# VSI Discovery and Configuration Protocol (VDP) (Working Draft)

*Proposed Resolutions to subset of comments against  
802.1Qbg Draft-1*

*Version 05d*

*09/15/2010*

# Station State Machine (One Instance per VSI)

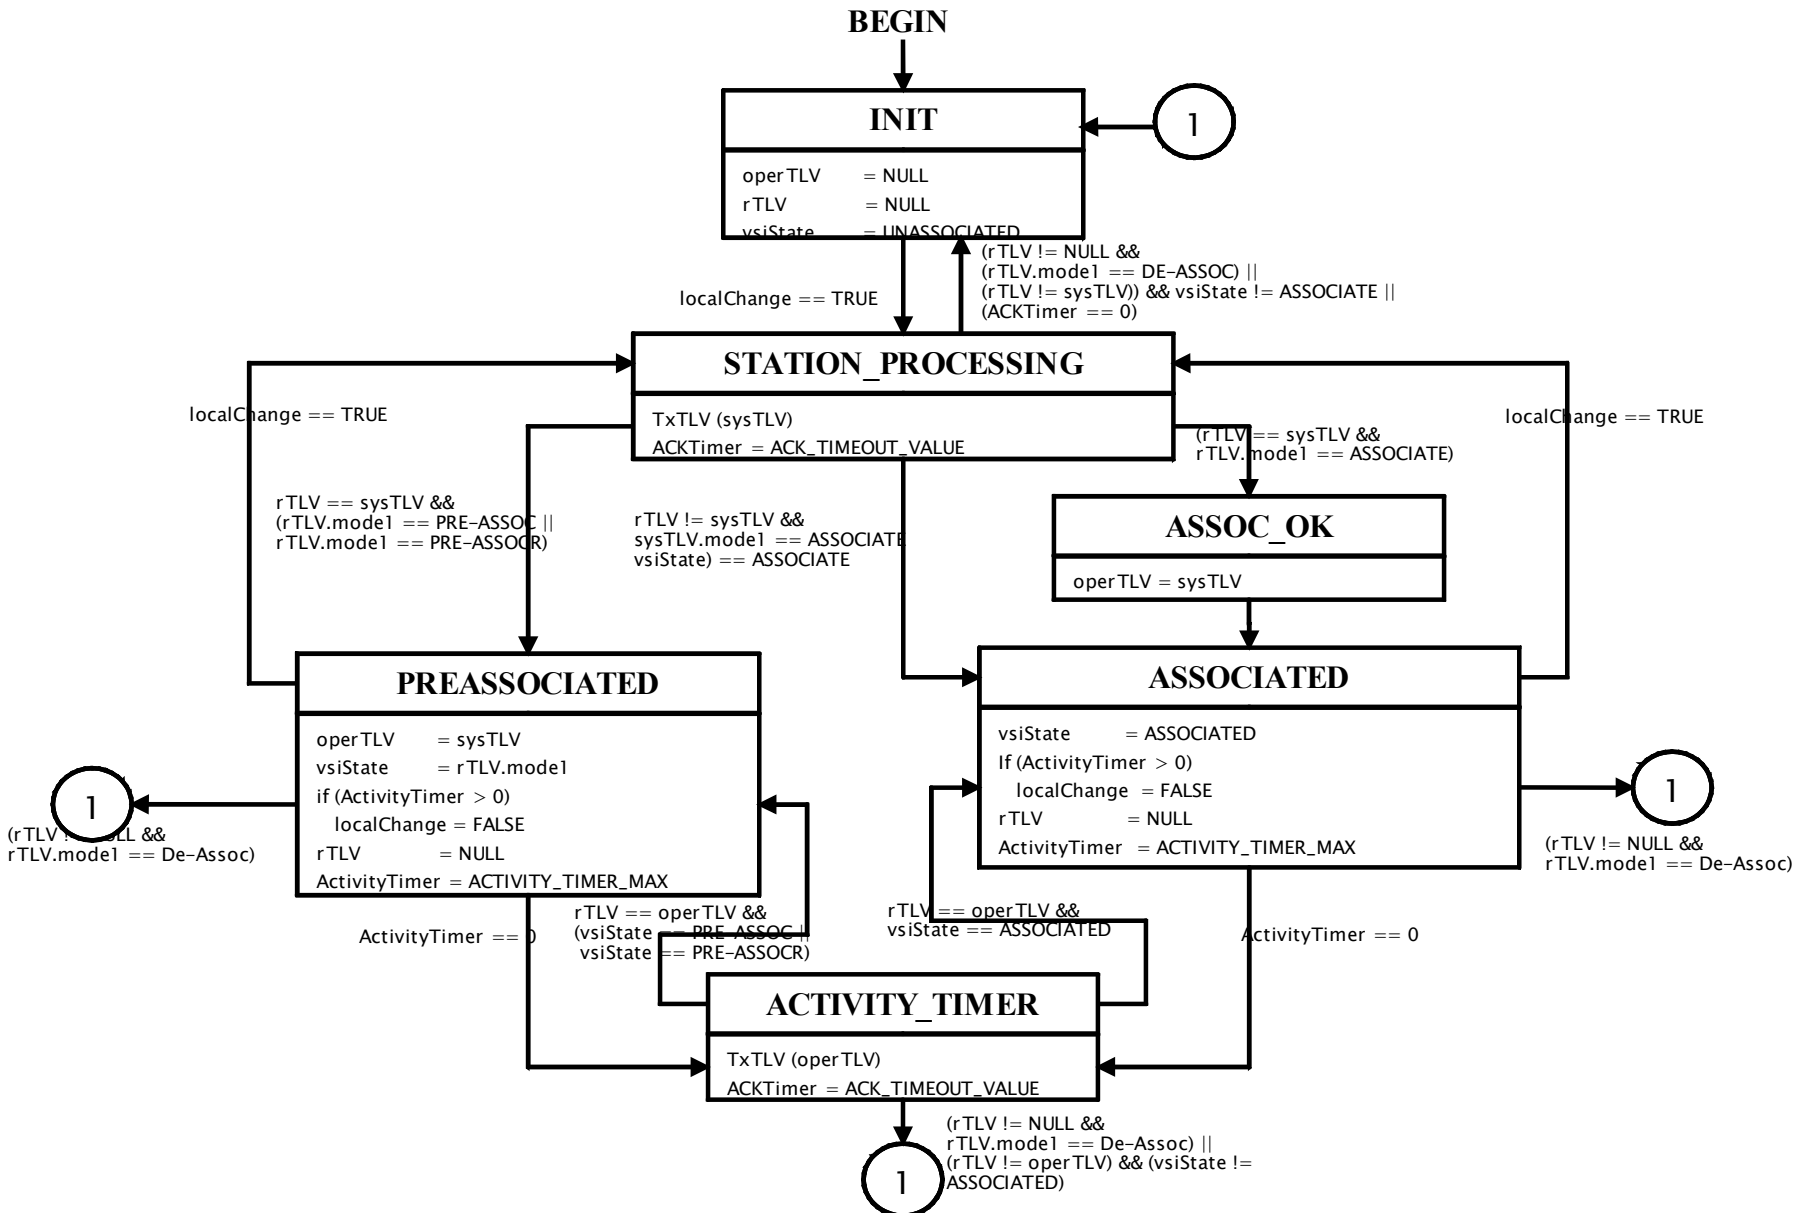
1. Compliance to IEEE Protocols State Machines Conventions (Ref: IEEE 802.1AB x.xx)
2. Changed timer expiration events to comply with IEEE state machines style.
3. Changed state machine layout to match IEEE state machines.
4. Misc. other style changes in state machines to make them consistent with IEEE state machines.
5. Updated local variables and procedures names and description for additional clarification.
6. *Ensured that changes do not impact state machines operation other than style and layout.*
